Project Name: Grand River Condos-Rezone I-1 to PR 17

REVIEW SHEET SUMMARY

ITEM REZONE I-1 to PR 17

PRELIMINARY PLAN-GRAND RIVER CONDOS

SHEET 1 OF 2  
 PRELIMINARY PLAN FOR  
**GRAND RIVER CONDOS**

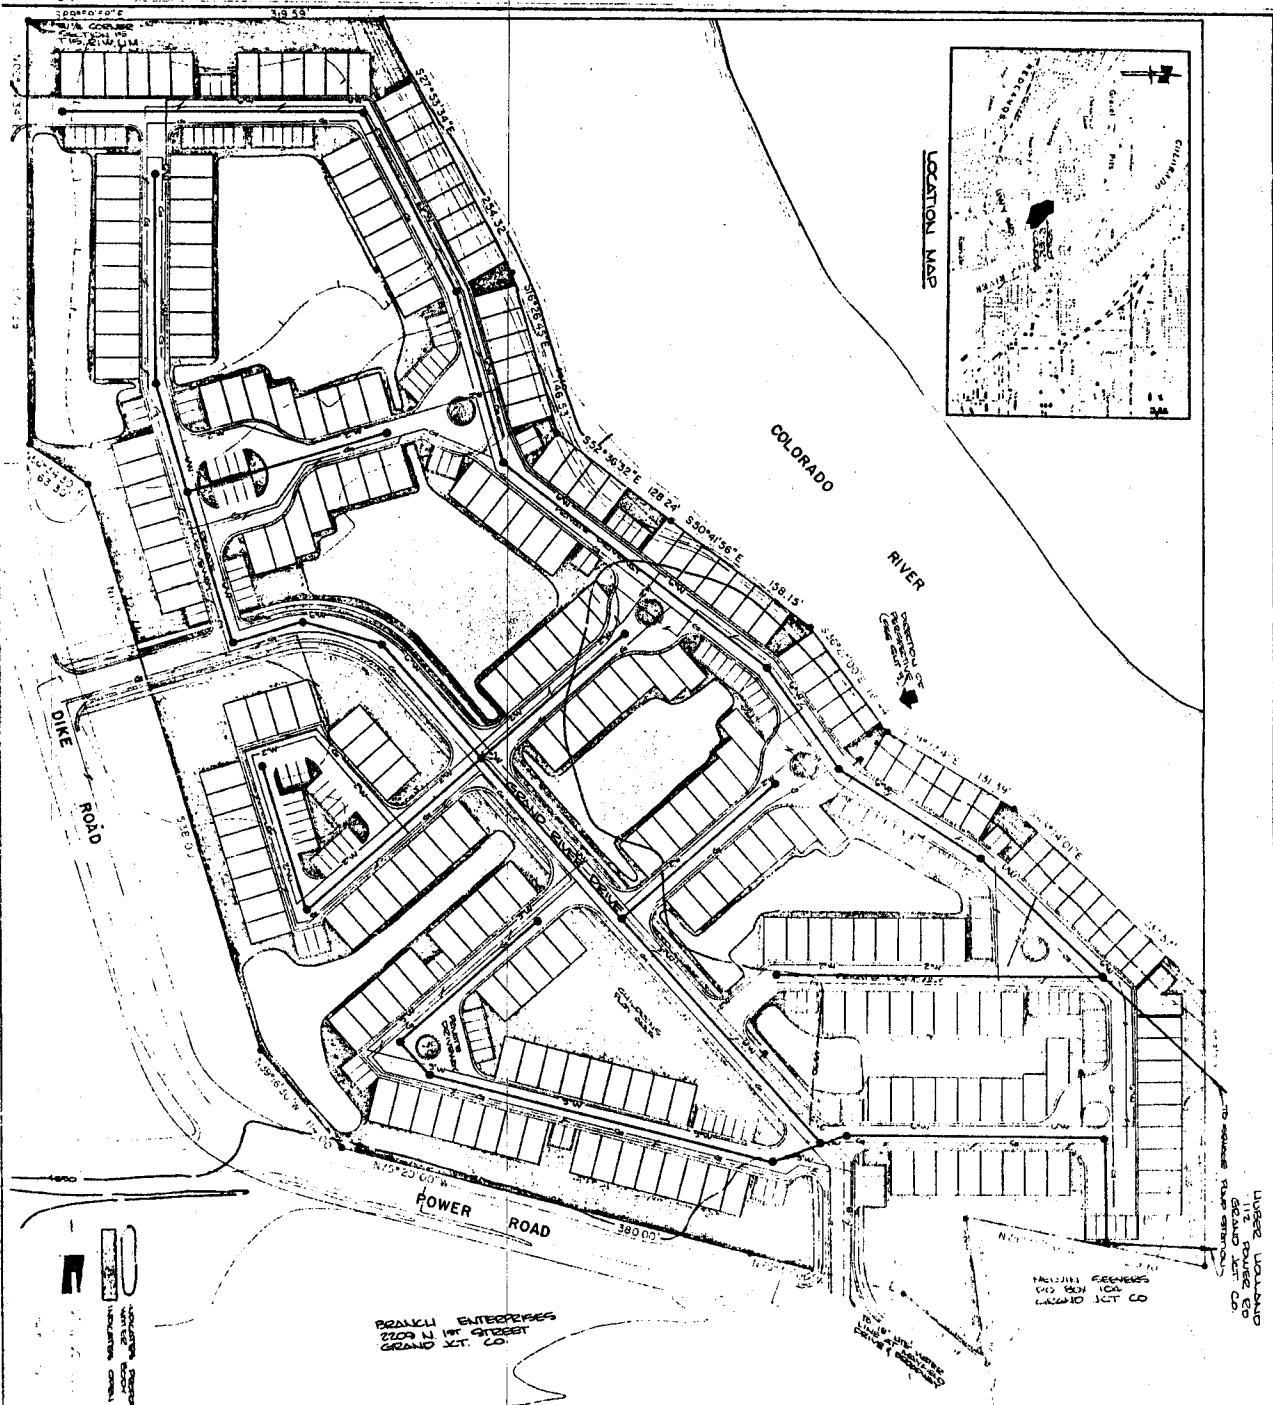
<u>DATE REC.</u>	<u>AGENCY</u>	<u>COMMENTS</u>
11-10-80	CITY UTIL	No structure built in the floodway of the 100 year flood plain may connect to the City-County sewer system. If this is to be a public sewer system, a utility easement must be provided where the sewer mains are located on private property or in private driveways. A sewer main under buildings, as shown, would be unacceptable. Some units would be difficult to serve with system as shown. The sewage lift station was designed to meet existing zoning and use. An enlargement of the lift station due to a change to higher density zoning should be paid for by the developer requesting the higher density.
11-10-80	UTE WATER	Water services for this development would come from the extension of an 8" water main from the North side of Hwy. 340 where it is intersected by Brach Drive (Pioneer Village South) at the developer's expense. It will also be required of the developers to participate in the expense of the existing extension which presently ends at the stated connection point. Extension policies, connection, tap and development fees in effect will apply.

11-12-80	CITY PARKS & REC.	Very poor use of available space on layout of units. (see red notes on blue print) 10 or 12 units all in a line is not quite "state of the art" planning--(I hope). An additional 252 units in an area, as congested as 340 & Grand Ave is at 8 and 5, is not going to help this matter at all.
11-13-80	CITY FIRE	Nearest adequate water main, according to our information is in Mesa Vista at its intersection with Hwy. 340. Water main sizes indicated are inadequate. Minimum 8" looped lines must be used. Hydrant spacing is also inadequate. Spacing must be no more than 300' between hydrants with no structure more than 150' from a hydrant. <u>All roadways in development must meet Uniform Fire Code, 1979 edition, requirements.</u> We have no objections to this rezone. As this is within the city, we would be responding two engines, one from station #1 and one from station #4. Fire Flow Survey required for each building prior to issuance of building permit. Private driveways shown do not meet requirements for fire equipment access.

11/14/80 Transp/Eng. The Power Road entrance is shown in the curve. This should be relocated to a tangent section of Power Rd.  
The traffic "islands" shown on the private drives are safety hazards and probably maintenance problem  
Traffic circulation and emergency vehicle access into the area to the right of the dike road entrance (public street) is very poor.

11/17/80 City Eng. My comments are the same as the Utilities Director concerning sanitary sewers.  
The 100 year "floodplain" and "floodway" limits and elevations should be shown on the plan. The project is clearly in the floodplain and will require submission of an application for floodplain permit. It is not clear to me where the floodway limit is in relation to the buildings along the river. No filling of any kind is permitted in the floodway. This plan appears to be based on some filling along the river bank to encroach the proposed buildings to a straight line on the existing curved bank. Does this result in filling the existing floodway. If the buildings are able to be constructed outside the floodway but along the bank similar to as shown what structural precautions will be made to prevent flood scour from undermining the buildings.  
Dike Road and Power Road should be dedicated to a 33 ft. half right-of-way and power of attorney for full street improvements should be obtained by Development staff prior to filing of the final plan

The proposed scheme of public/private streets is reasonable provided no on-street parking is allowed sufficient off-street parking is available, and easements are granted for all utilities outside of the public streets.  
As indicated by their drainage calculations, large storm flows are routed through this site and the site is low resulting in their proposal to install flap gates on the outlet pipes to the river. The storm drainage system will have to be very carefully designed so as to protect this high-density development from storm runoff flooding. The potential for flooding at this site is high unless the drainage system is well designed and constructed exactly as designed. I am not sure I understand or agree with their implied concept of storm detention when the site is right next to the river. Why not have a "positive" a drainage outlet system as possible?

1. Sewer mains should not be located under buildings. Developer should contribute to enlarging the lift station.
2. Water system, hydrant locations, fire flow survey, and emergency vehicle access need to be designed and approved to Fire Department specifications.

3. Rezone to residential is appropriate, however, the type and density need to be thoroughly examined.
4. Redesign access as per transportation engineers comments. The traffic islands would be inappropriate.

5. The floodplain and floodway limits need to be shown. Basic questions need to be answered concerning the floodplain/floodway and its relationship to the site and proposed structures.

6. Dike road and Power Road half R-O-W's (33') needed and P.O.A.s for full street improvements on these as well.
7. On street parking should be prohibited and enforced.

8. Applicant should demonstrate why they should not have a positive drainage system rather than the proposed "flap gate" system.
9. Recommend taht a strip along the river be utilized as open space rather than built upon.

The floodway has been determined to be the top of bank of the Colorado River. The floodway has been located on the plan and no units will be constructed in the floodplain.

The intersection of Grand River Drive with Dike/Power Road has been relocated to a tangent section.

The traffic "islands" are in the private streets and it is our desire to leave them in the project for visual relief and local traffic control. During final design, we may elect to eliminate these islands; however, we prefer the option.

The area to the right of the Dike Road-Grand River Drive intersection has been improved by adding an additional entrance to that cluster.

Floodway has been located per previous comments. No filling or construction is planned within the floodway with the exception of pre-rapping the bank.

The drainage system proposed is to be positive drainage to the Colorado River. Flap gates will not be utilized.

Extensive site grading will be done on site to raise all units above the 100 year floodplain. The ponds created by the site grading will have sufficient volume to accommodate 100 year flood plain encroachments.
